FORT CALHOUN STATION
TECHNICAL EVALUATION REPORT
ON THE IPE SUBMITTAL
HUMAN RELIABILITY ANALYSIS

FINAL REPORT

U.S. Nuclear Regulatory Commission
Office of Nuclear Regulatory Research
Division of Systems Technology

Final Report, September 5, 1996

Figure 2-1. Decision tree for selection of model.

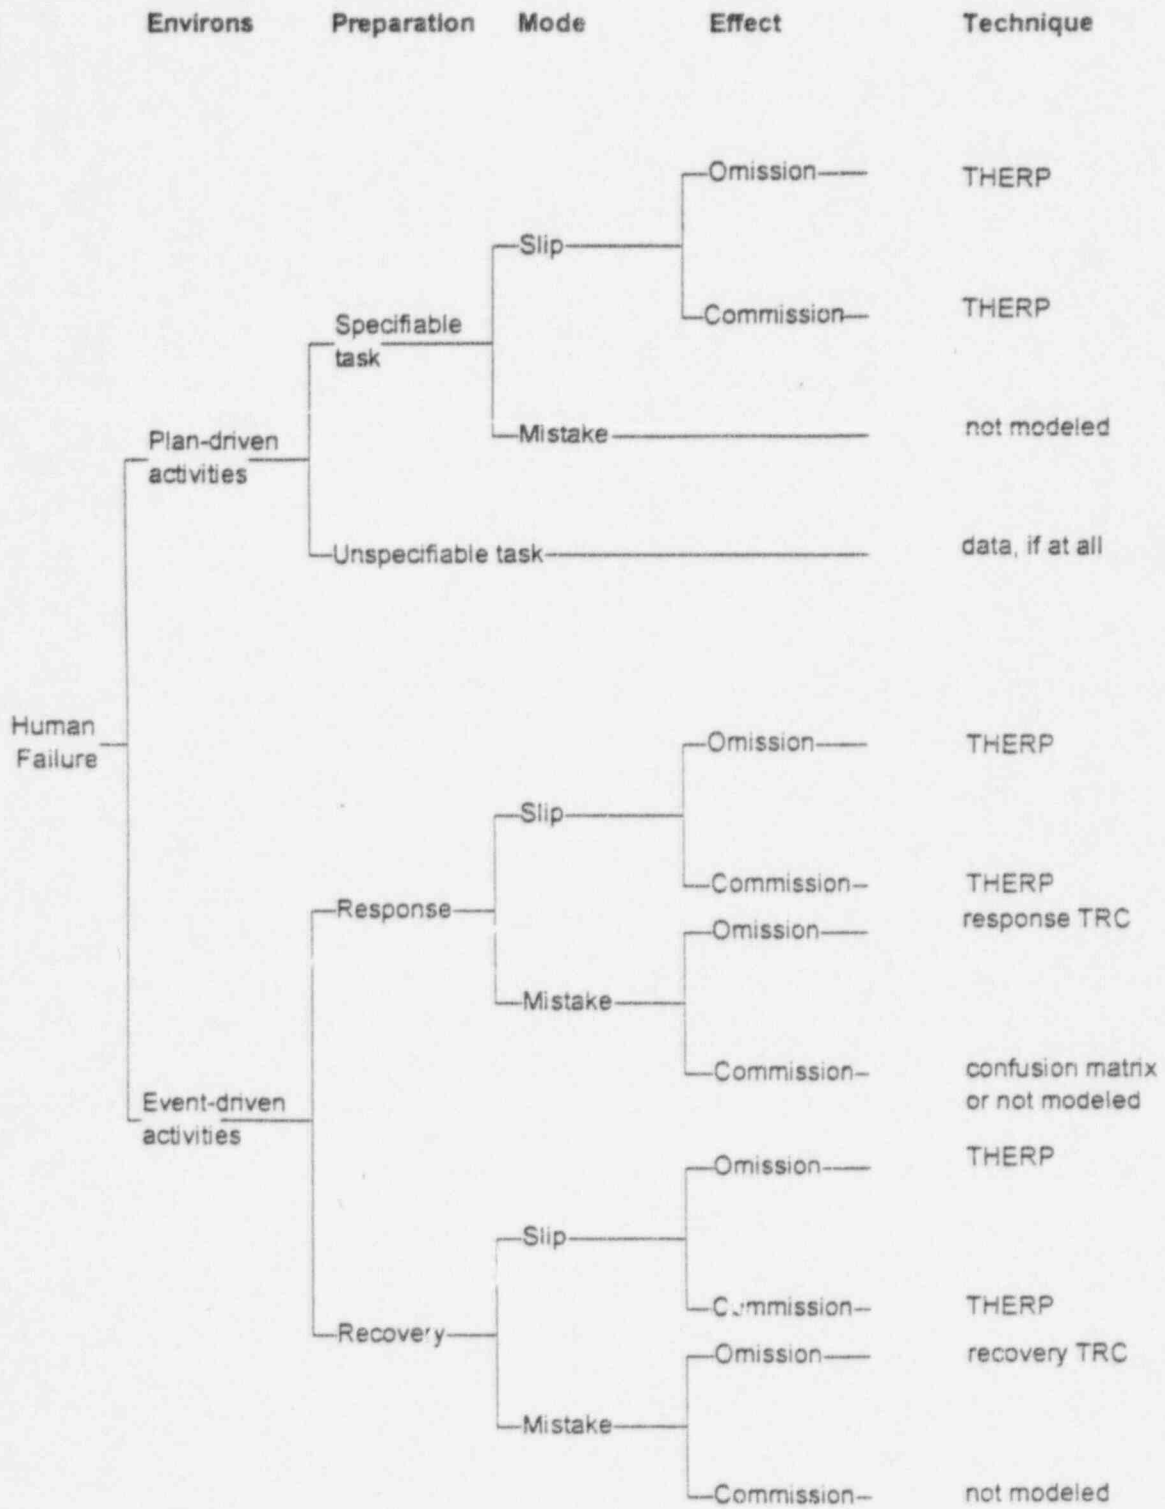
In the example applications, this decision tree appears to have been followed. In general, "plan-driven activities" refers to pre-initiator human actions in that there is no inherent time limitation by which actions must be completed. Within this category, "unspecifiable tasks" refers to situations that have not previously been planned, such as *ad-hoc* or novel repairs. No modeling of this category was performed in the FCS IPE.

In addition, no modeling of errors of commission associated with mistakes in the "event-driven activities" was performed in the FCS IPE. The confusion-matrix method identified in Figure 2-1 is a technique that allows an analyst to specify the likelihood of misdiagnosing some event "x" as event "y" based on such factors as the similarity of indications and alarms; it was developed by Potash for use in the Oconee PRA performed for the U.S. Nuclear Safety Analysis Center (NSAC) and is described in [7]. Since the U.S. nuclear industry's adoption of symptom-based emergency operating procedures, no PRA has used this method because of the perceived lack of need to model operators' errors in diagnosis.

The licensee does not describe the logic applied to decide which post-initiator actions should be modeled as slips and which as mistakes. Figure 2-1 identifies the selection of an appropriate model for quantifying slips and mistakes, but does not describe the choice between a slip and a mistake for any particular action. Since using the different models can lead to significantly different probabilities of failure, the lack of guidance as to whether to select an action as a slip or a mistake is a potential limitation in the method and in the IPE.
